CONDITIONAL APPROVAL
PLAN APPROVAL EXPIRES: 01/29/2018

Rossier Bar
6399 Old Hwy 18
Town of Stockton, 54481
Portage County

Revision; Plan Type: New

Object Type: Commercial Water Treatment Device Regulated Object ID No.: 1578661
Revision

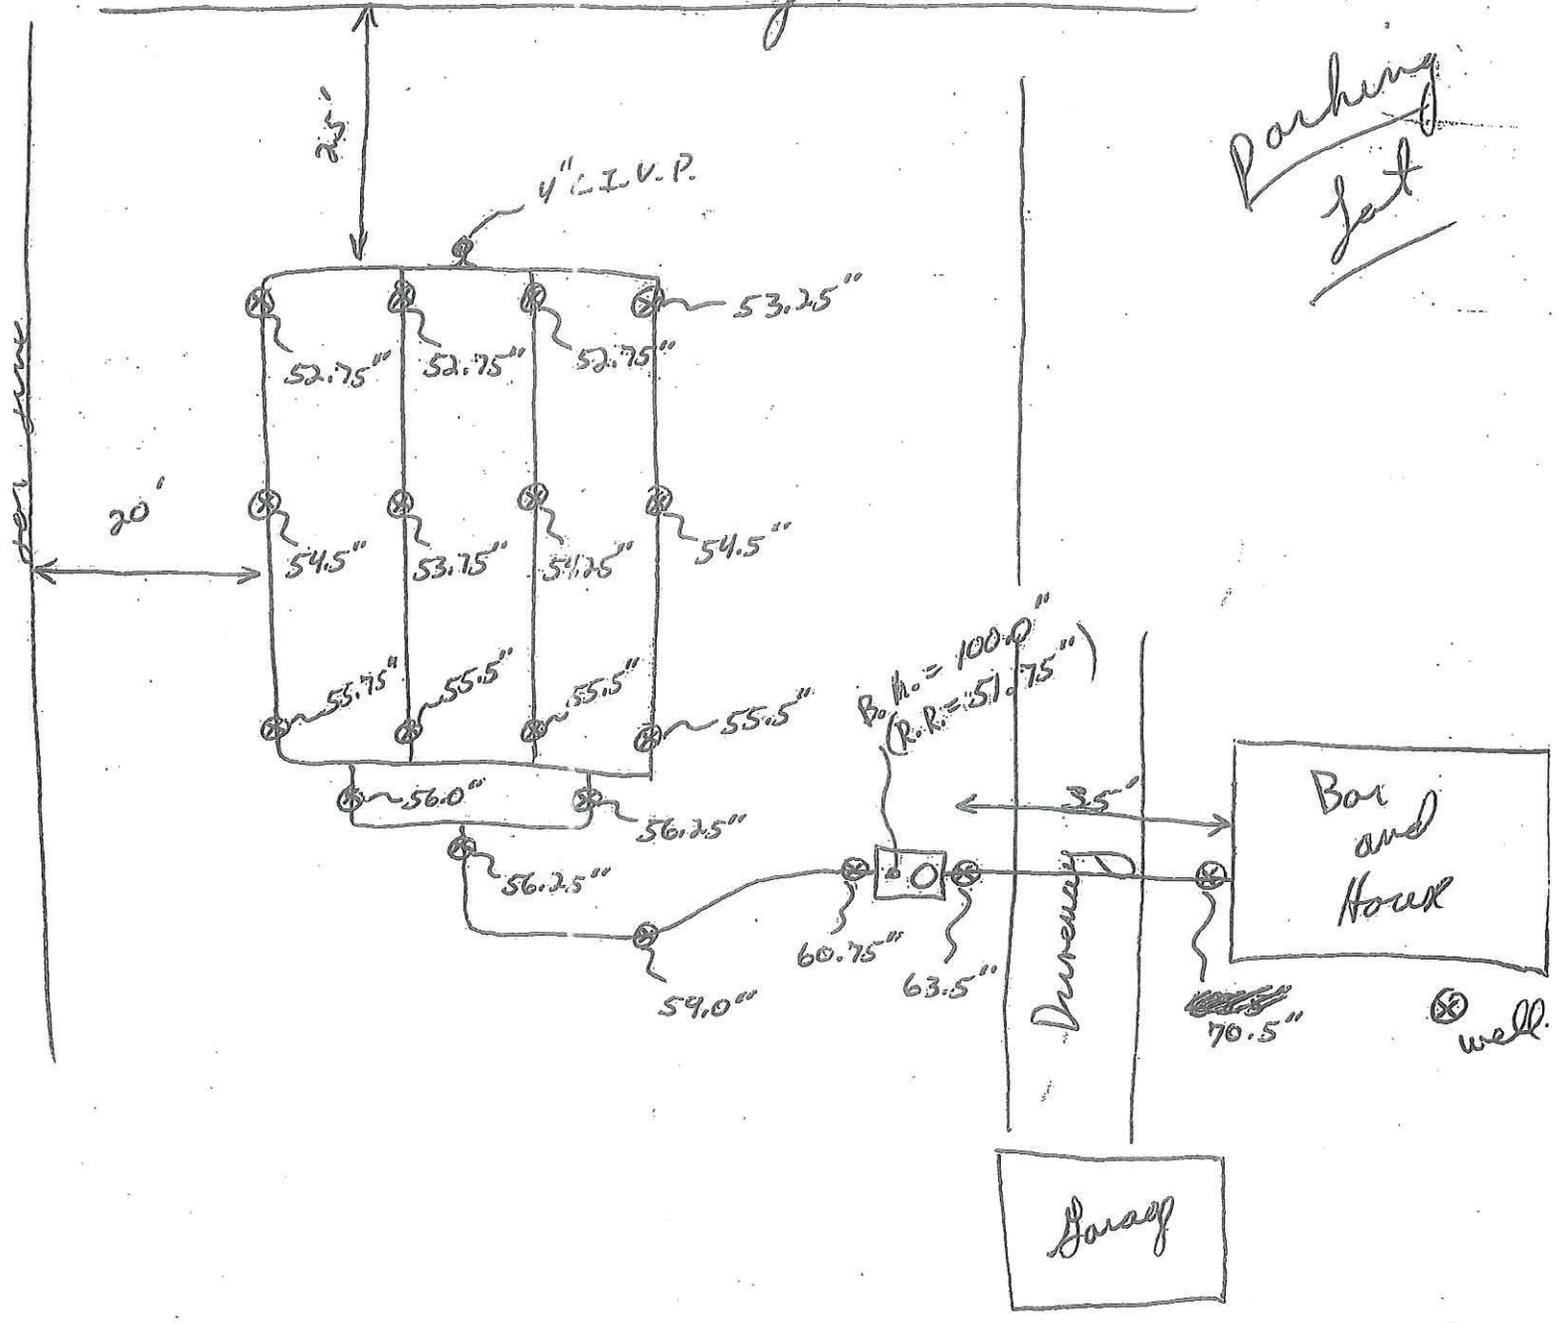
Conditionally APPROVED

SEE CORRESPONDENCE
